AGENDA
DANIA BEACH CITY COMMISSION
REGULAR MEETING
TUESDAY, MAY 9, 2017 - 7:00 PM

A RESOLUTION OF THE CITY COMMISSION OF THE CITY OF DANIA BEACH, FLORIDA, APPROVING THE WHISPERING OAKS SITE PLAN (SP-111-16) SUBMITTED BY THB ISLES, INC. FOR PROPERTY LOCATED AT APPROXIMATELY 4900 SW 25th AVENUE IN THE CITY OF DANIA BEACH, FLORIDA, AS LEGALLY DESCRIBED IN EXHIBIT "A"; PROVIDING FOR CONFLICTS; FURTHER, PROVIDING FOR AN EFFECTIVE DATE. *(Continued from March 28, 2017 and April 25, 2017)*

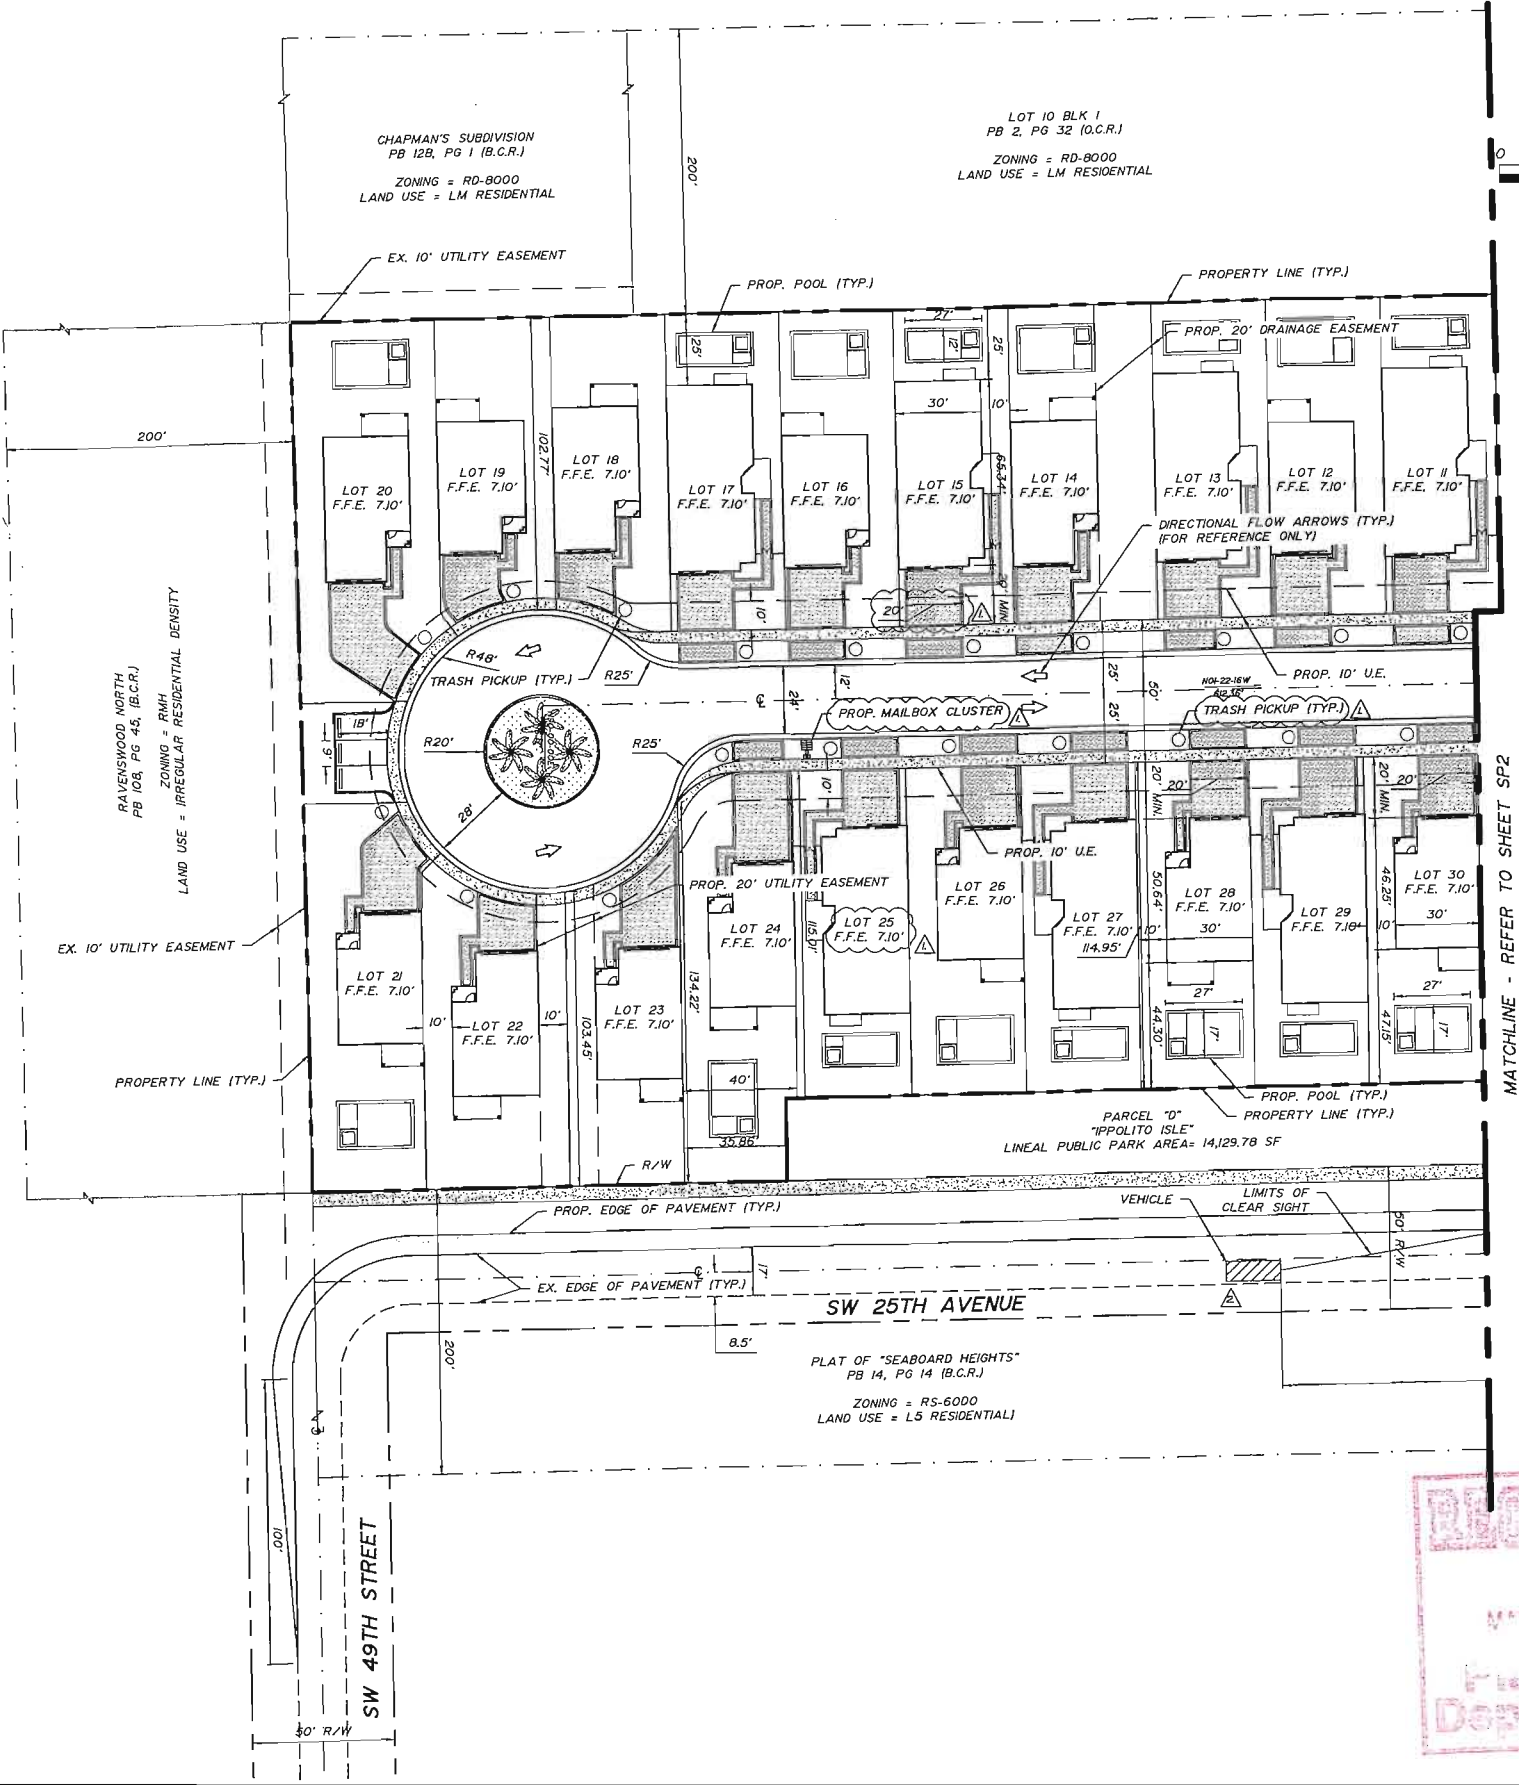
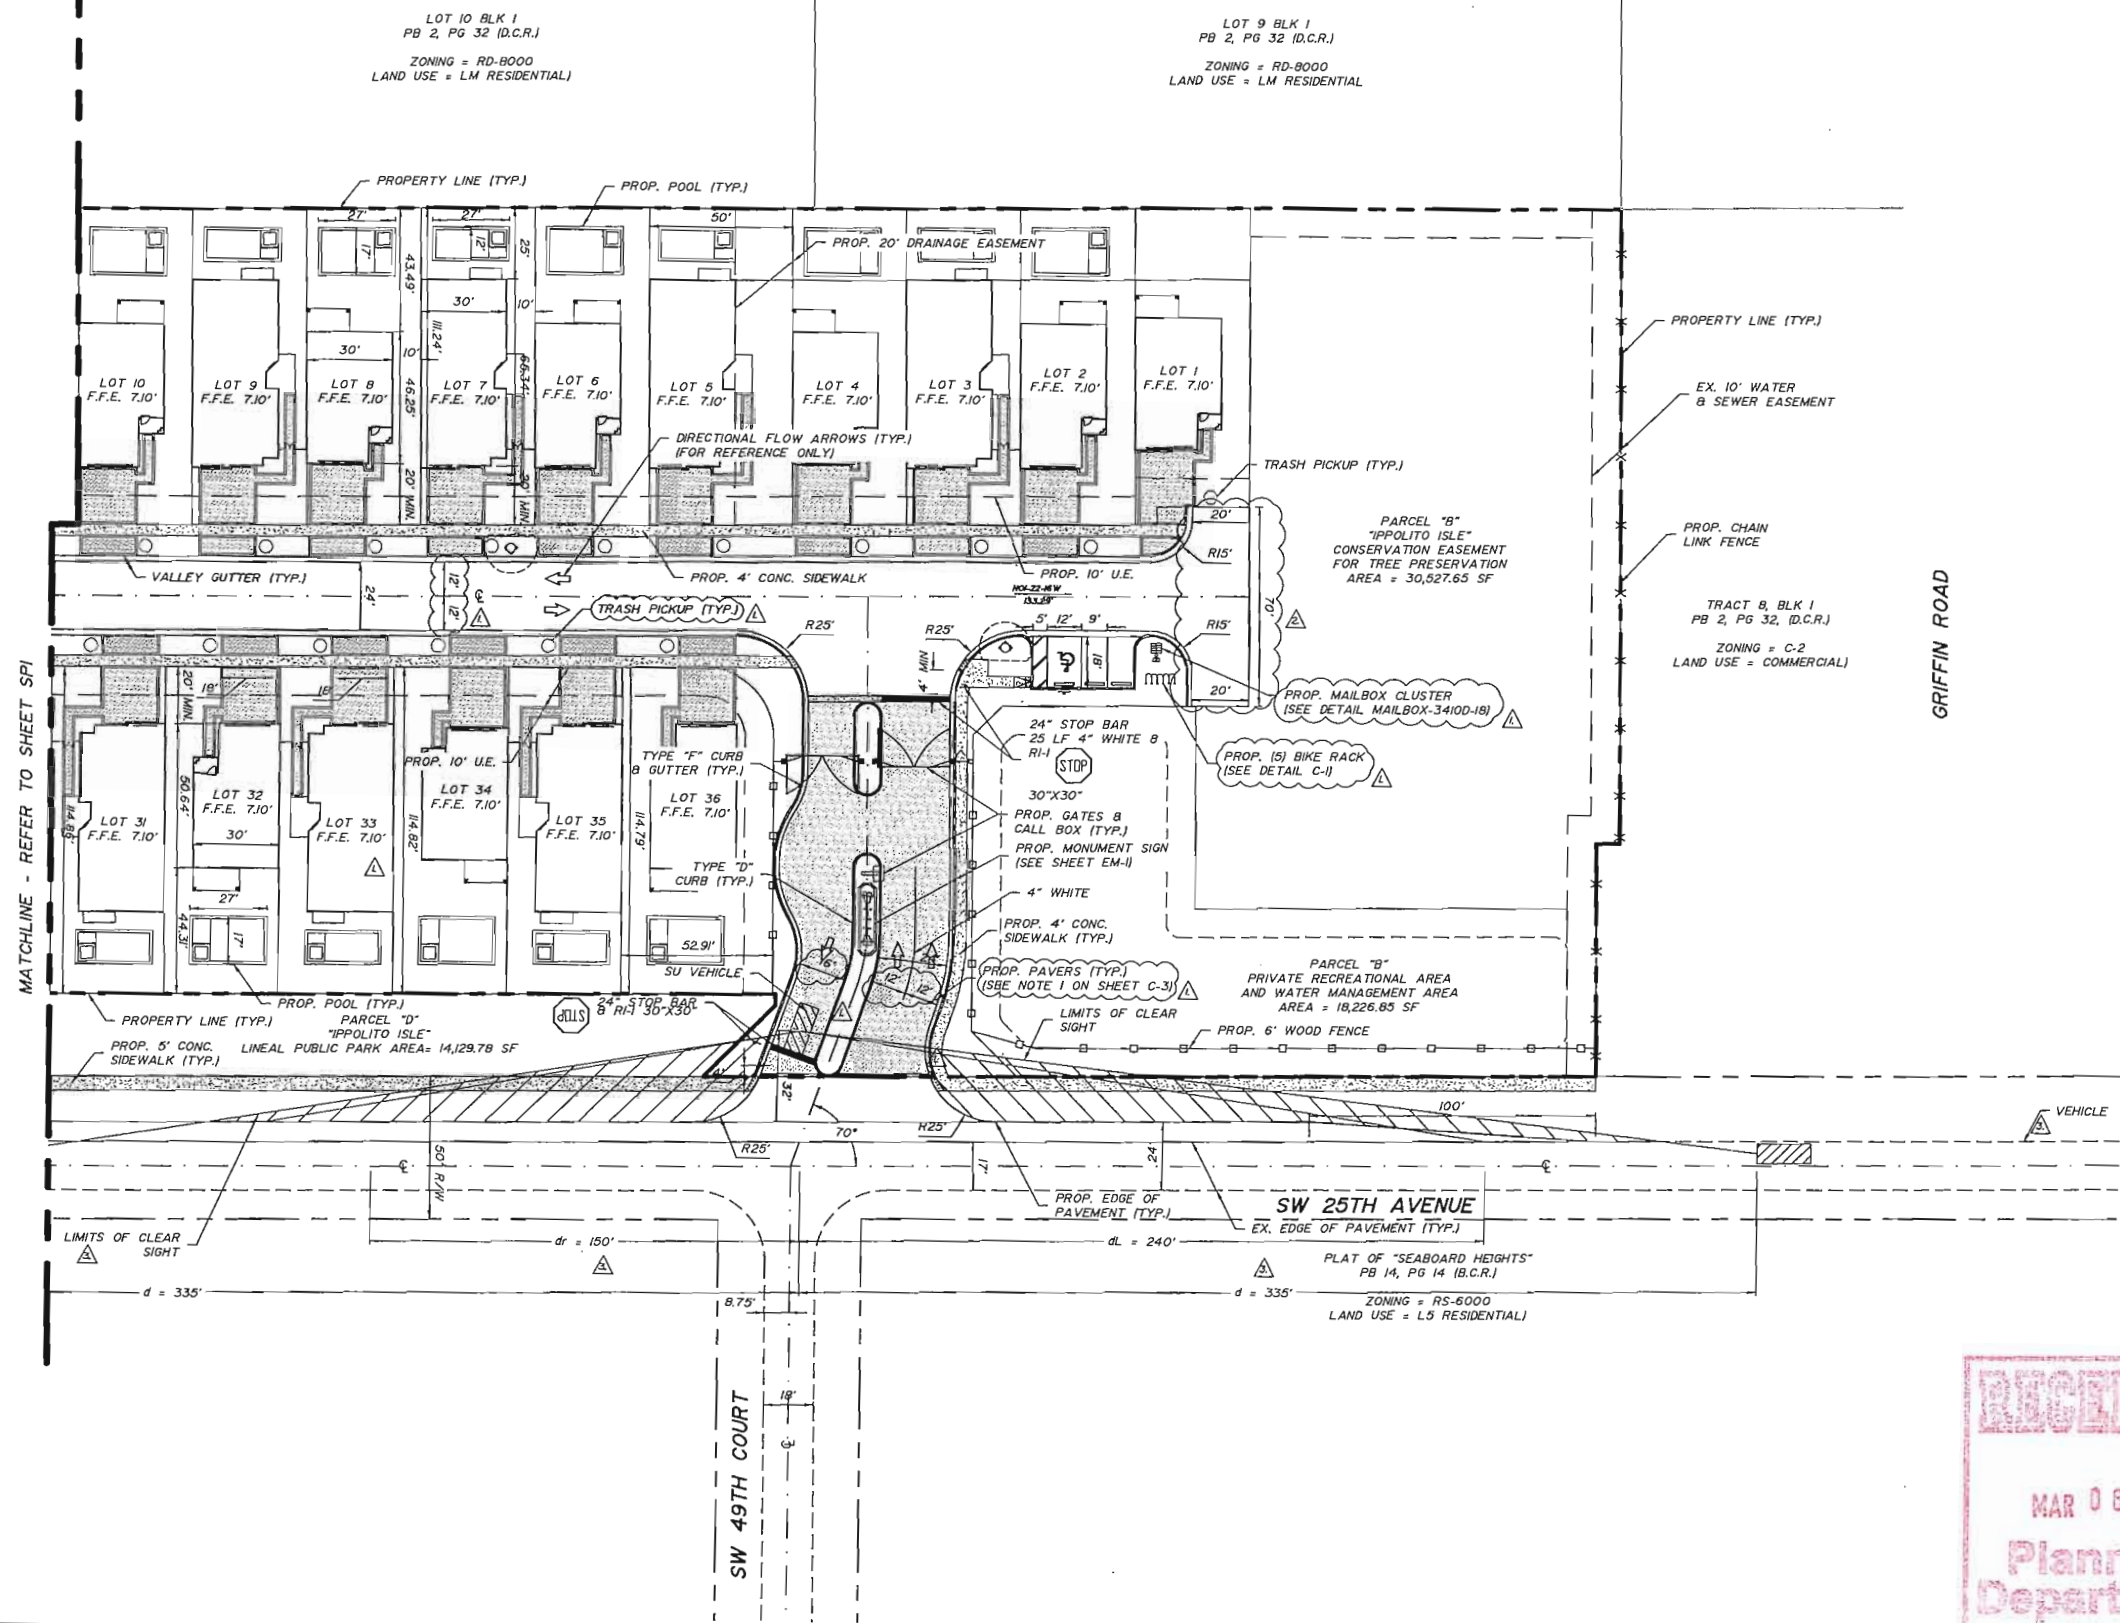
25. "Lot Calculations" table on Sheet SP-1:
 - Identifies minimum yard setbacks as "TBD at site plan review". Delete this language as minimum requirements are identified in Section 205-10. Identify required and provided setbacks on site plan now. 2nd time requested.

Response: FFE has been indicated on plans. Please refer to sheets SP-1 and SP-2.

Response: Flood Risk Information has been provided on sheet SP-1 in the "Flood Zone Data" section.

Response: A table showing a projection of water demand, and sewage and solid waste generation has been provided on sheet SP-1 in the "Water & Sewer Demand Calculations" section.

Project Number
201625
Sheet Number
FA-1

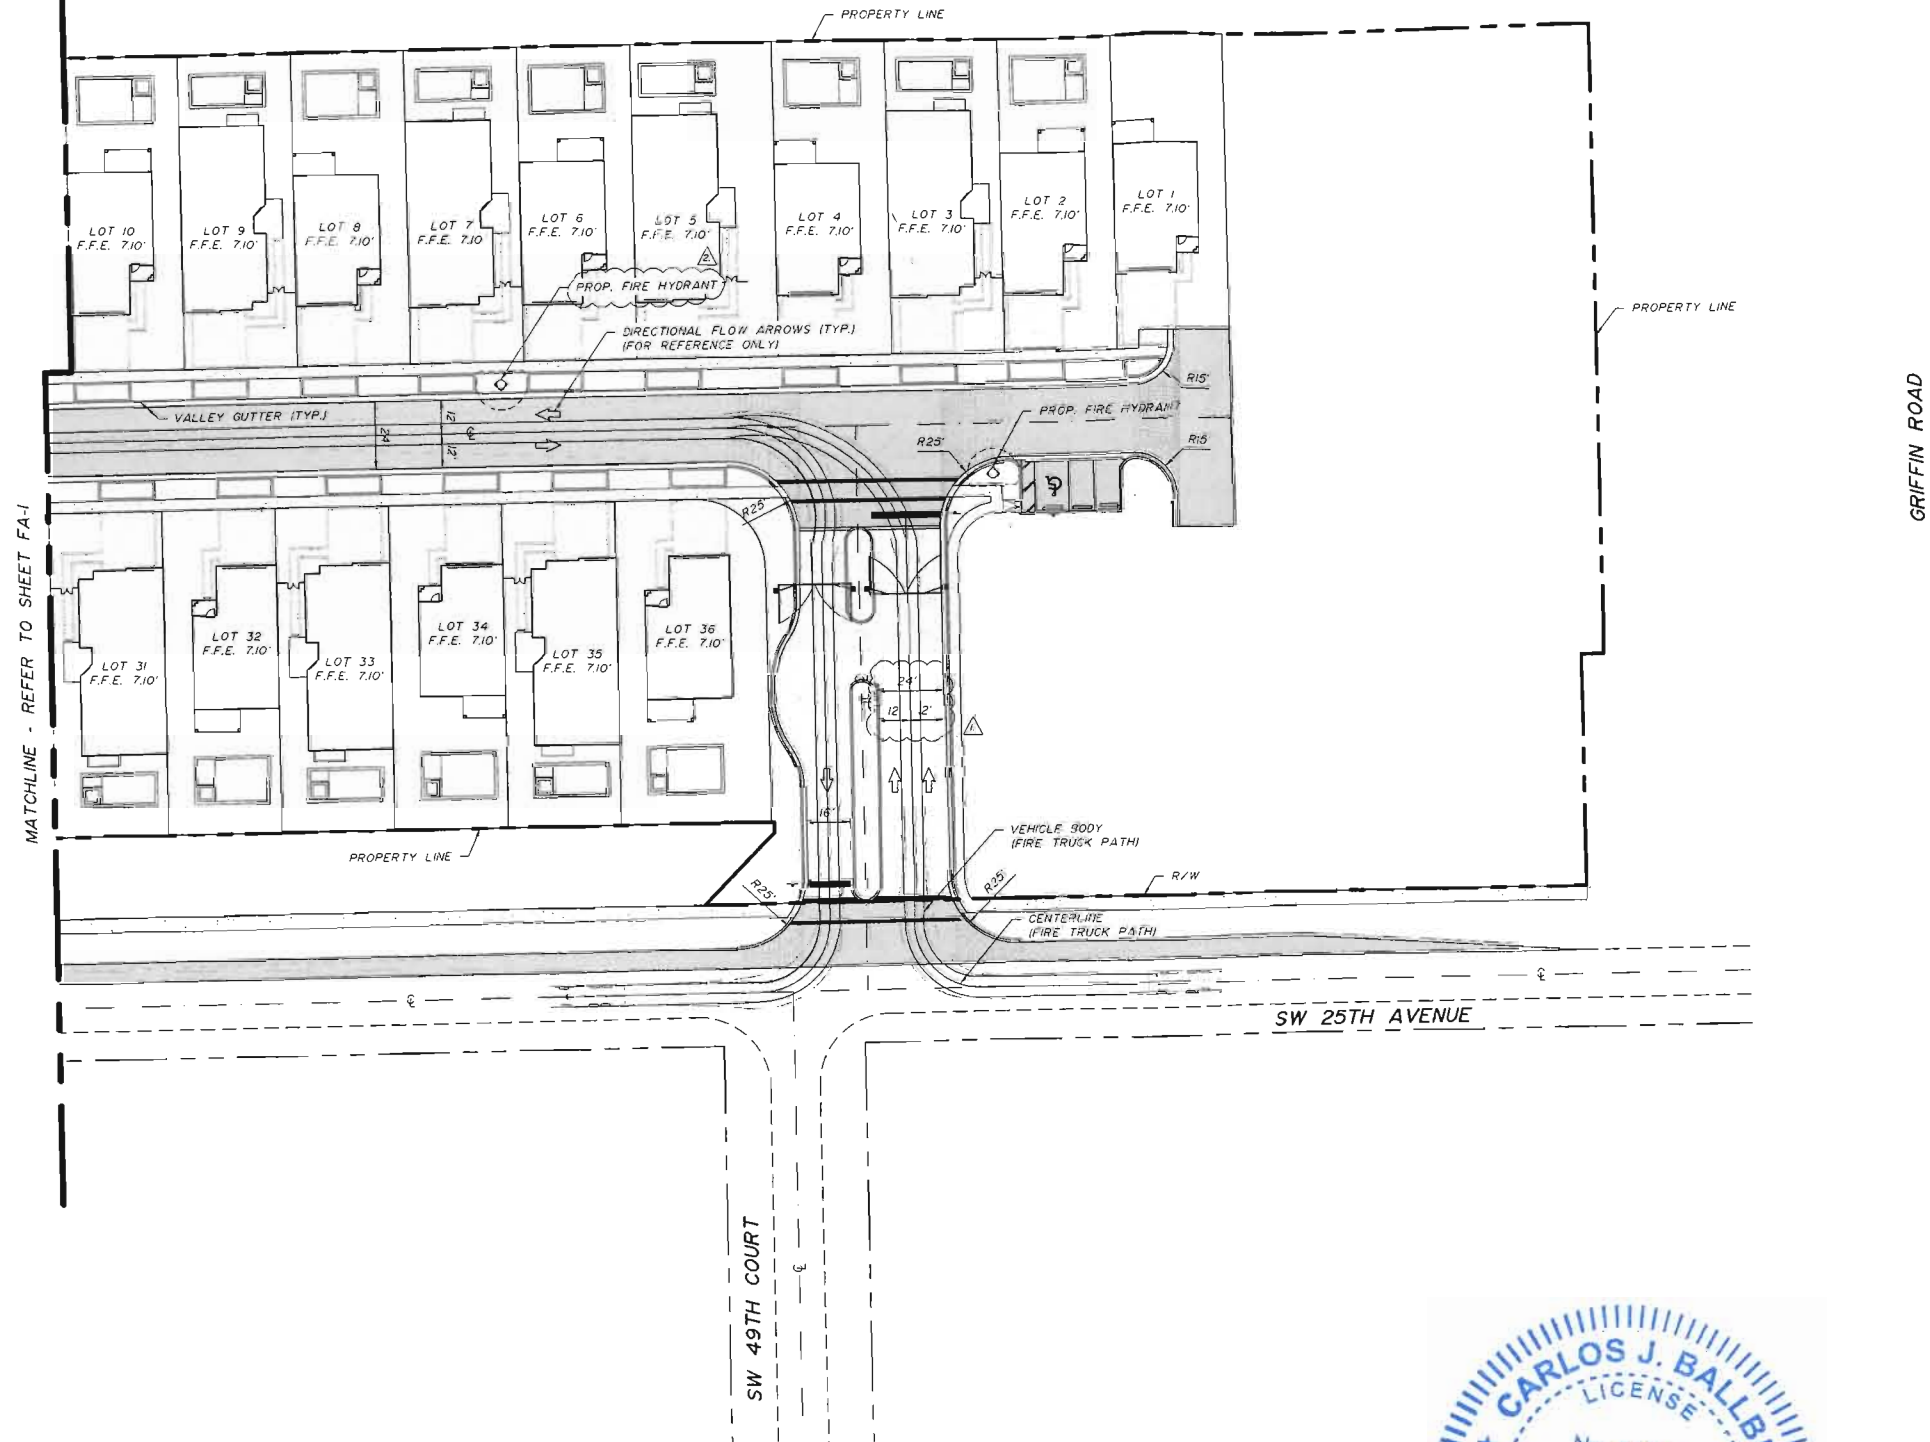
Response: All turning radii have been demonstrated on sheets SP-1, SP-2, FA-1, & FA-2. Additionally, the inside radius of the turn-around circle at the south end of the project is now 38'. Please refer to sheet FA-1.
